Contract #: 04-0120F4Cty: SF/ALA Rte: 80 PM: 13.2/13.9File #: 69.25B**QUALITY ASSURANCE -- NON-CONFORMANCE REPORT****Location:** Changxing Island, Shanghai, PRC**Report No:** NCR-000273**Prime Contractor:** American Bridge/Fluor Enterprises, a JV**Date:** 20-May-2009**Submitting Contractor:** Zhenhua Port Machinery Company, Ltd (ZPMC), Changxing Island**NCR #:** ZPMC-0247**Type of problem:**

Reference Description: East Tower, Lift 1 unacceptable weld on backing plate at diaphragm corner piece**Description of Non-Conformance:**

NON-CONFORMANCE REPORT TRANSMITTAL

Job Name: SAS Superstructure
Document No: 05.03.06-000238

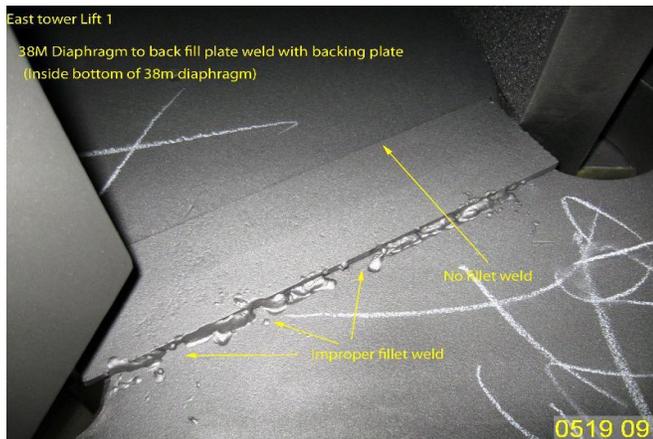
During random visual inspection of East Tower, Lift 1, after grit blasting, QA observed that tack welds used to attach steel backing were placed external to the weld joint but were not made by continuous fillet welding for the full length of the backing plate at weld joint ESD1-A165F/J-97. This weld was previously tested and accepted by ZPMC personnel.

AWS D1.5-2002, Section 3.3.7.6 - Tack welds used to attach steel backing and placed external to the weld joint shall be made continuous by fillet welding for the full length of the backing or shall be removed.

The proposed resolution is acceptable. The intermittent tack welds attaching the backing bar have been removed, and the welds in question have been accepted by MT and UT as shown in the attached documents. The Department concurs that Non-Conformance ZPMC-0247 is closed.

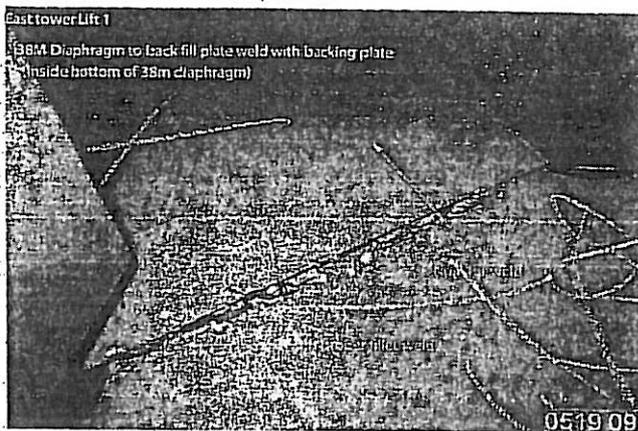
During random visual inspection of East Tower, Lift 1, after grit blasting, QA observed that tack welds used to attach steel backing were placed external to the weld joint but were not made by continuous fillet welding for the full length of the backing plate at weld joint ESD1-A165F/J-97. This weld was previously tested and accepted by ZPMC personnel.

AWS D1.5-2002, Section 3.3.7.6 - Tack welds used to attach steel backing and placed external to the weld joint shall be made continuous by fillet welding for the full length of the backing or shall be removed.

Steel backing tack welds were removed, in accordance with AWS D1.5-2002, Section 3.3.7.6, and NDT results indicating a sound weld have been submitted.
